ISSUED FOR CONSTRUCTION
6/02/17

Project: EWINGSDALE ROAD UPGRADE WORKS SUNRISE BLVD DETAIL DESIGN		Client: BYRON SHIRE COUNCIL	
Draftsperson: JT	Checked: SAW	Sheet Size: 0 1	Drawing No. A1B15408-SL
Designer: JT	Approved: [Signature]	Scale: AS SHOWN	Date: 04/08/16

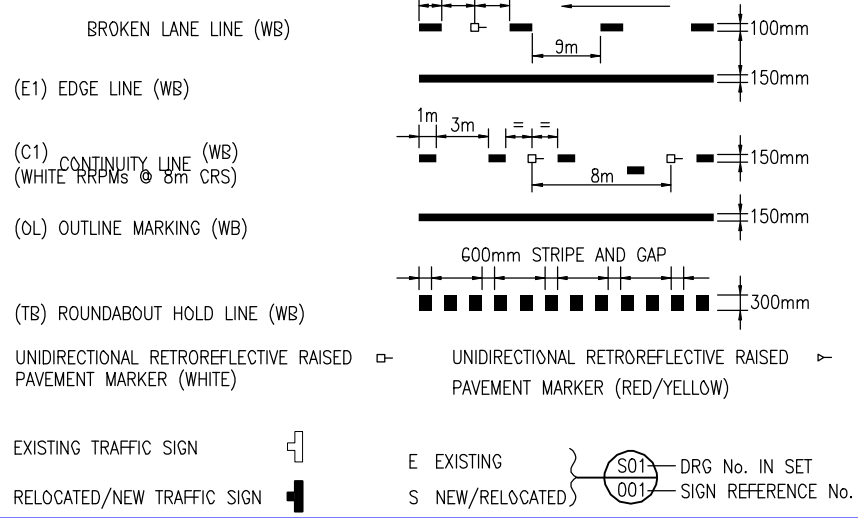
Yellow line required - 20m before and 10m after pedestrian kerb ramp (with flow of traffic) measured from outside ramp edge (continue line through ramp).

50 Area sign (R4-10) No Longer Used - A default urban speed limit of 50 in all built-up areas, in the absence of other speed limit signs. Retained if unclear with speed limit sign (R4-1).

Add RMS R2-9 Sign: "LEFT LANE MUST TURN LEFT"

Traffic median to be extended into lane marking as per existing painted medians

Install merge right signage W4-9B, W8-15B & G9-73A Remove additional pavement arrow

All straight/turning arrows in left turning lane to be removed and replaced with left turning only.

Relocate to departure side of roundabout

Install merge right signage W4-9B, W8-15B & G9-73A

Roundabout pavement markings to comply with Delineation - Section 11, Figure 11.2

Yellow line required - 20m before and 10m after pedestrian kerb ramp (with flow of traffic) measured from outside ramp edge (continue line through ramp).
